PROPERTY ADDRESS: 420 East Park Avenue

SUMMARY OF REQUEST: New Construction – Single Family

Proposal-Updated for October 9, 2013 Hearing

Charlotte Historic District Commission - Case 2013-137

ELEVATIONS

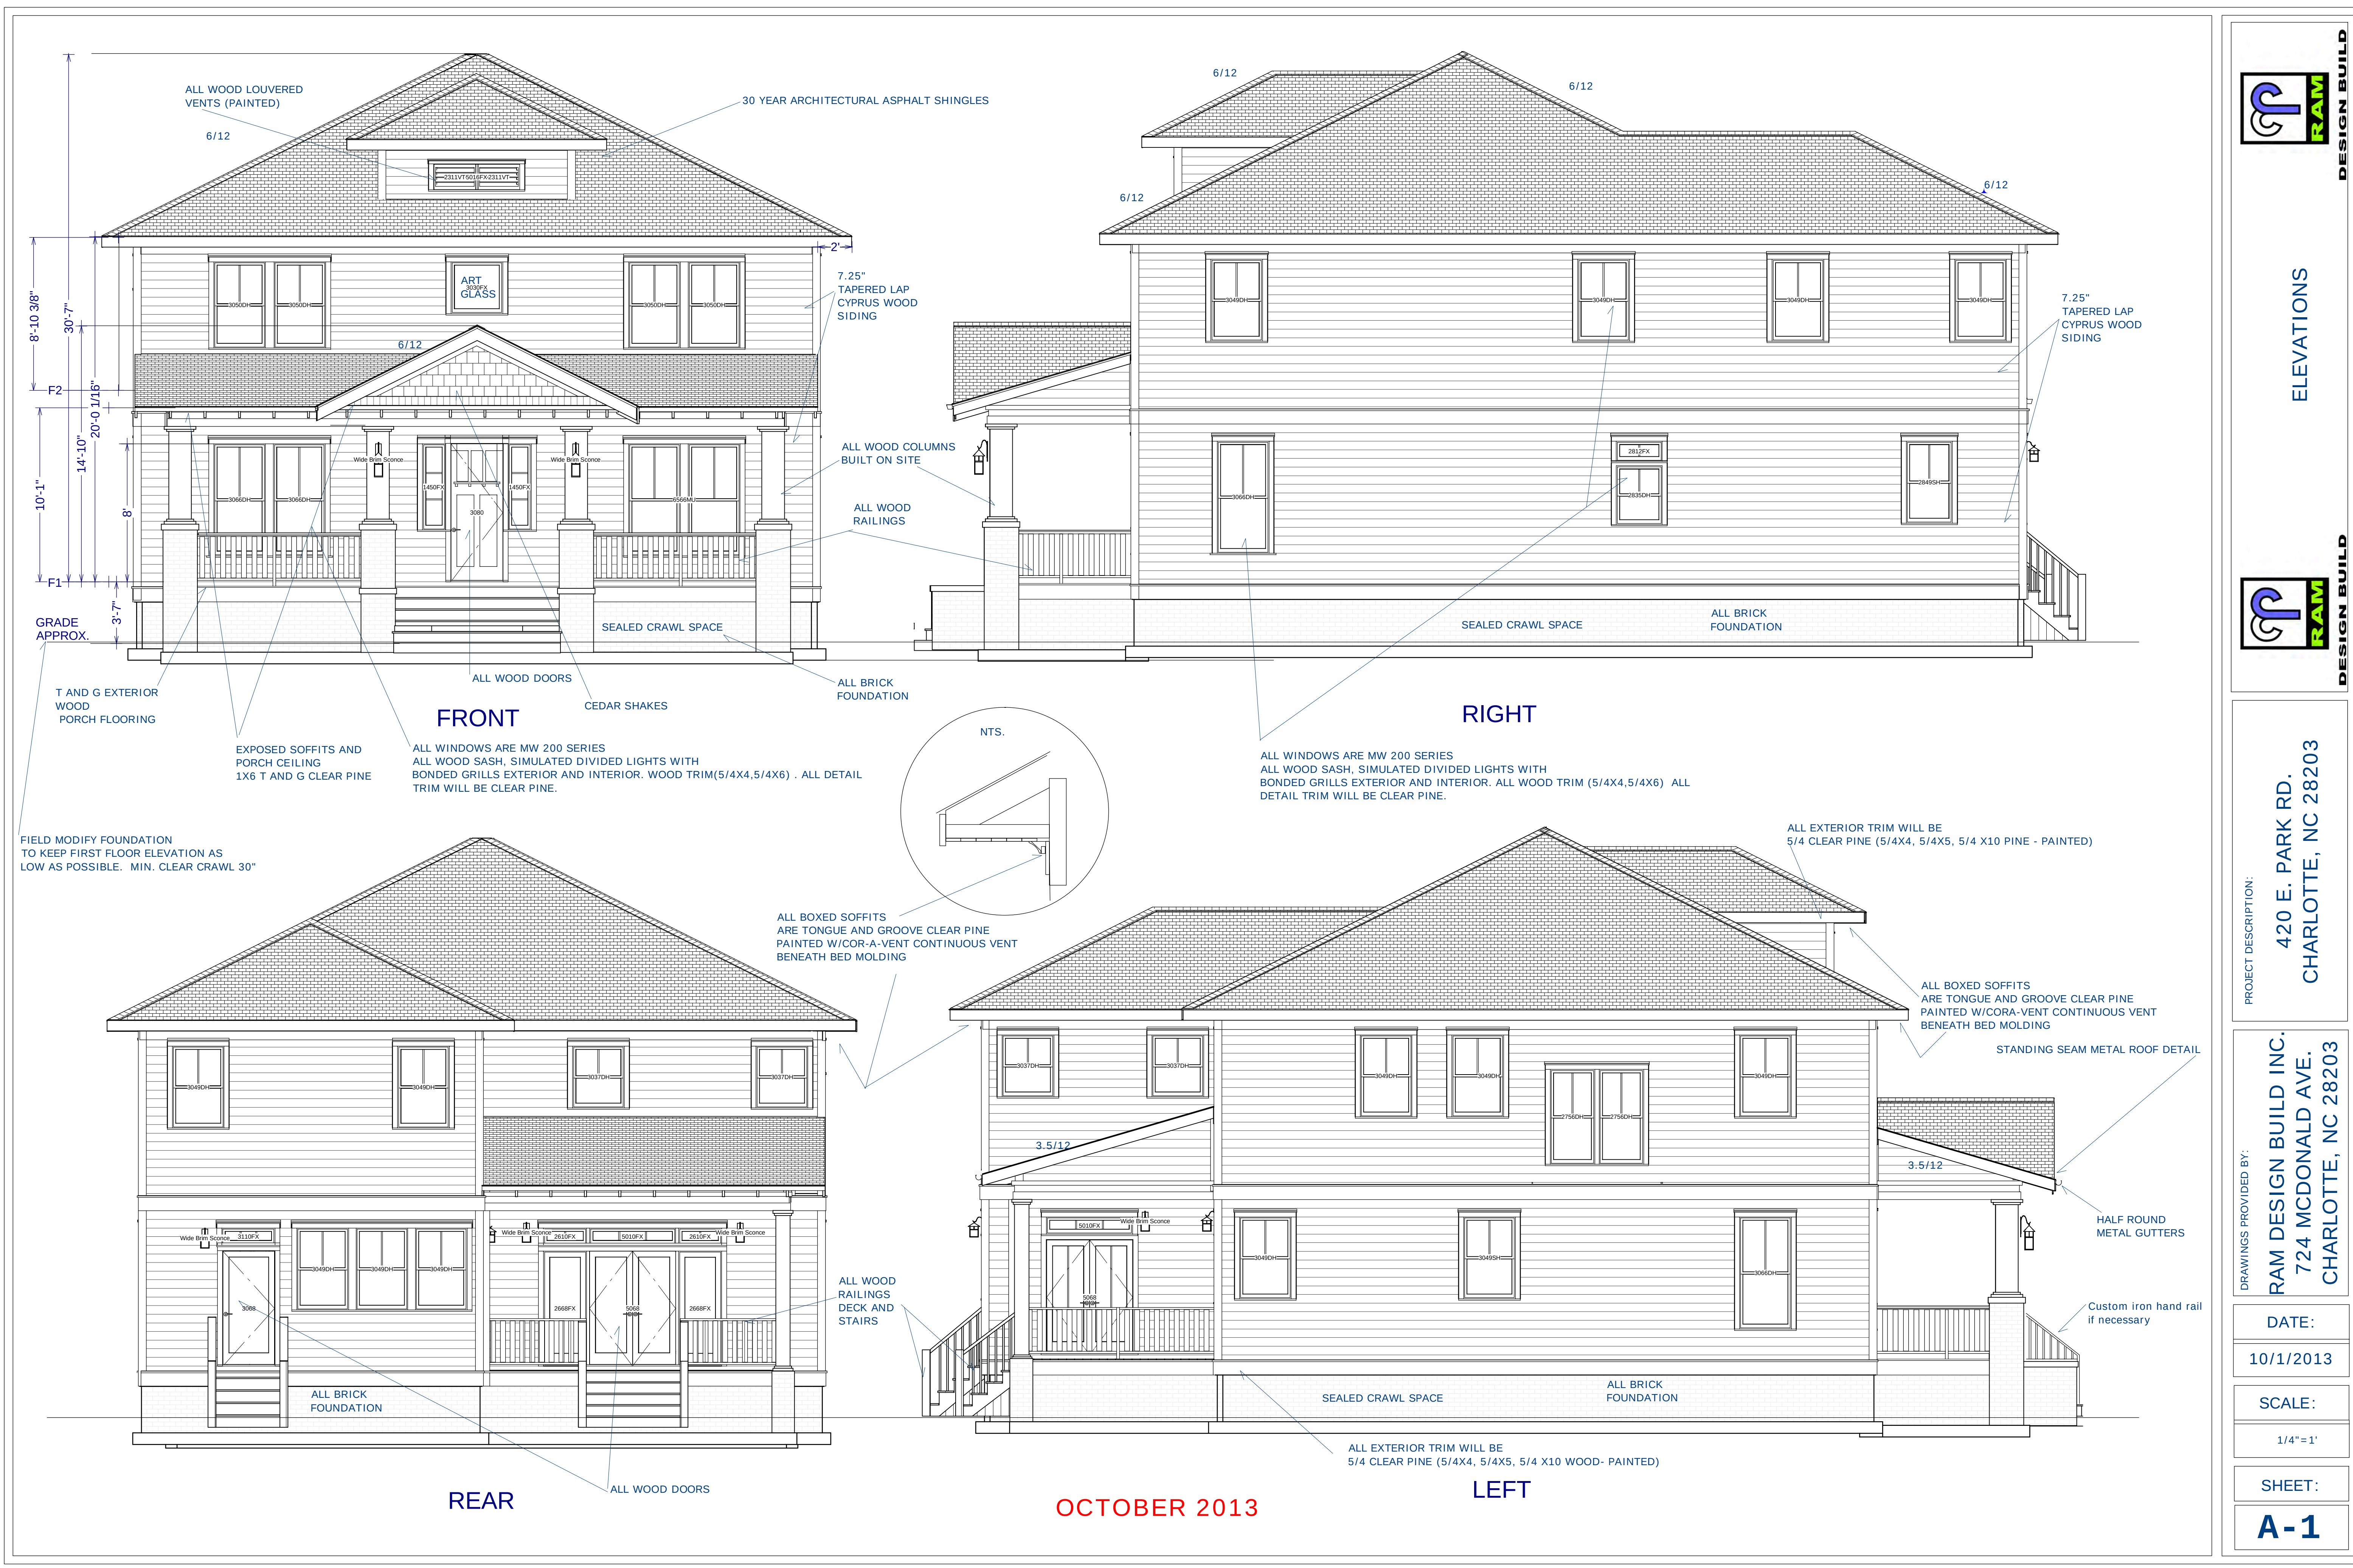
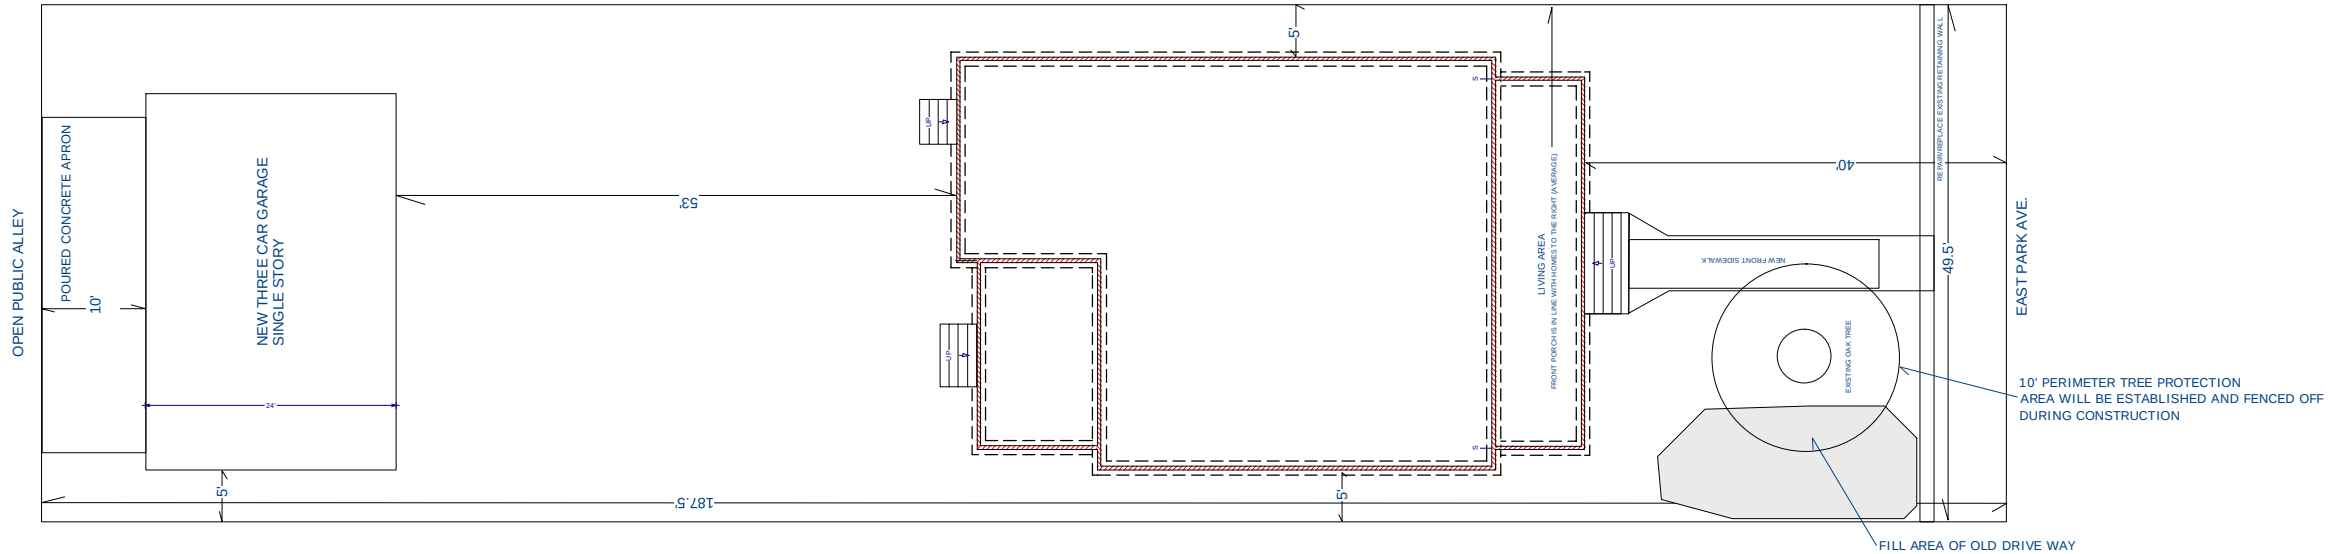
Staff believes the revised proposal meets all of the applicable Guidelines with the exception of Fenestration. The window arrangement on the second floor left elevation is an unresolved detail.
